**PROPOSED ALTERATIONS FOR:
O'NEILL RESIDENCE.
LOT 47 #23 CURRAMBINE BOULEVARD,
CURRAMBINE. W.A**

Applicants Justification

ACOUSTIC REPORT

Figure 5 Swept paths associated with on-street bays

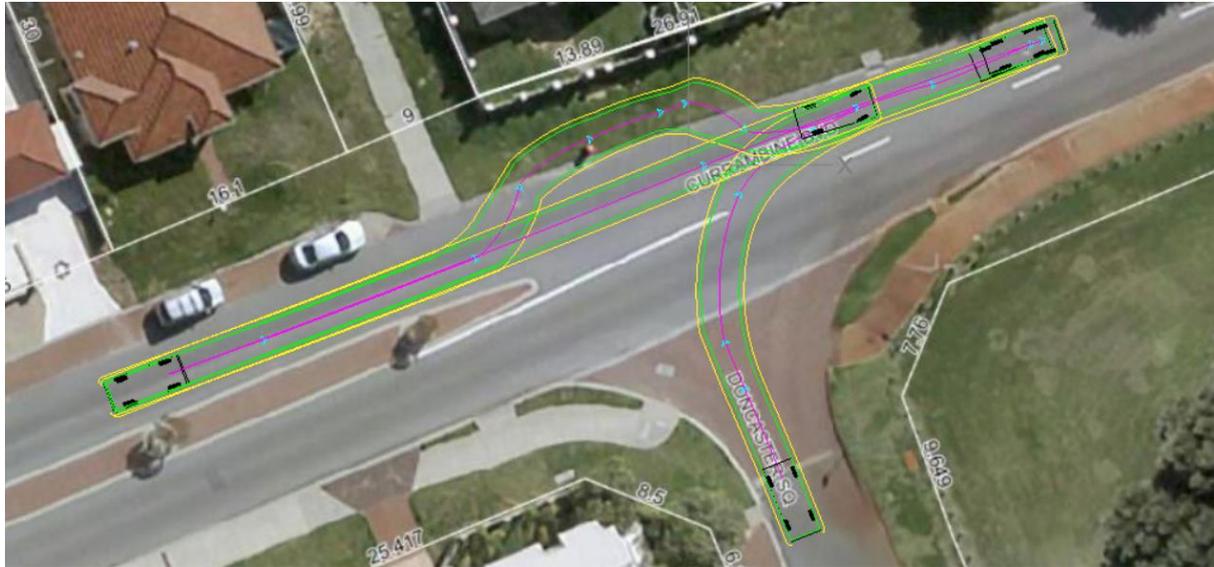
Embayments on Currambine Boulevard	
Comments by City of Joondalup	Applicant Response
<p>“Currambine Boulevard may be classified as an Access Road but it is currently functioning as a Local Distributor with approximately 1800 vehicles per day and it will undergo further activation in the future. The City’s current policy does not allow embayment’s on local distributors with the ones already on Currambine Boulevard being installed many years ago under the City’s previous policy. While noting that Liveable Neighbourhoods talks about access streets being up to 3,000 vehicles per day Currambine Boulevard does act as a Local Distributor with less”.</p>	<p>As outlined in MRWA’s document <i>Road Hierarchy for Western Australia Road Types and Criteria</i> an Access Road can accommodate traffic volumes up to 3,000 vehicles per day (vpd) in a built-up area. (https://www.mainroads.wa.gov.au/Documents/Road%20Hierarchy%20Criteria%20-%20April%202011.u 3158367r 1n D11%5E2392185.PDF)</p> <p>A Local Distributor Road can accommodate volumes up to 6,000 vpd. Both street types can accommodate on-street parking where there is sufficient width and sight distance to allow safe passing.</p> <p>Currambine Boulevard is currently defined as an Access Road.</p> <p>The proposed embayed parking bays allow sufficient width (as the bays are embayed and do not impact on the width of the eastbound travel lane) and there is in excess of 55m of sight distance, which is the required Approach Sight Distance for a speed limit of 50 km/h.</p>

<p>The City's current stance is that it does not support the construction of individual bays for individual developments within the City as this creates an ad hoc approach to embayment construction and a disorderly streetscape.</p>	<p>The construction of 2 embayed parking bays along the frontage of 23 Currambine Boulevard is unlikely to lead to a disorderly streetscape given the existing embayed parking to the west of the public access way.</p>
<p>Parking Bays on Mistral Meander</p>	
<p>Comments by City of Joondalup</p>	<p>Applicant Response</p>
<p>The bays on the verge do not comply with the verge guidelines when they are in use as they do not allow for pedestrians to have at least 1.5m clear access behind the kerb. The guidelines states;</p> <p><i>'Where there is no footpath on the verge, an area measuring 1.5 metres from the back of the kerb and running parallel to the kerb, must be landscaped in such a way that provides pedestrians the opportunity to walk on the verge.'</i></p> <p>The bays also create a visual and safety hazard being so close to the road pavement.</p>	<p>Two of the parking bays are proposed in tandem formation, with the 4.2m of the 5.4m length of these two bays located within the verge. While these car bays are unoccupied (which will be the majority of the time outside of morning and afternoon peak periods) there will be space to allow pedestrians to work along the verge. When the car bays are occupied any pedestrians walking along Mistral Meander would have to walk on the road.</p>

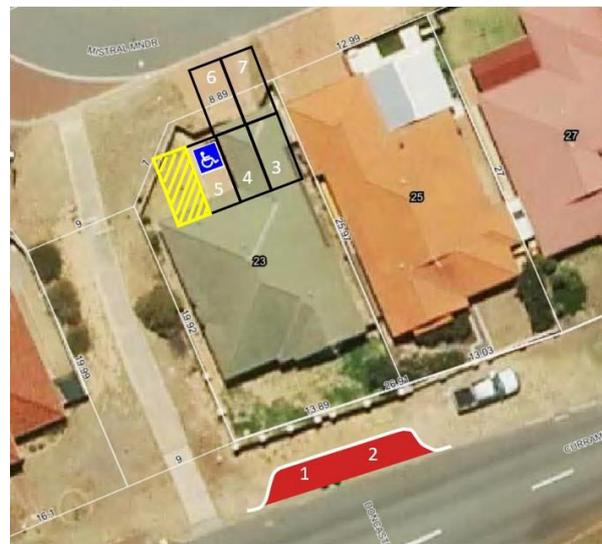
rather it is an allocation at the rate of 1 in 100 or part thereof.

The shared space adjacent to the ACROD bay can be used as a walkway. This is expressly set out in AS2890.6 Off-street parking for people with disabilities Clause 1.3.2 which states:

“a shared area adjacent to a dedicated space provide for access or egress to or from a parked vehicle and which may be shared with any other purpose that does not involve other than transitory obstruction of the area, e.g. a walkway, a vehicle aisle, dual use with another adjacent space.”
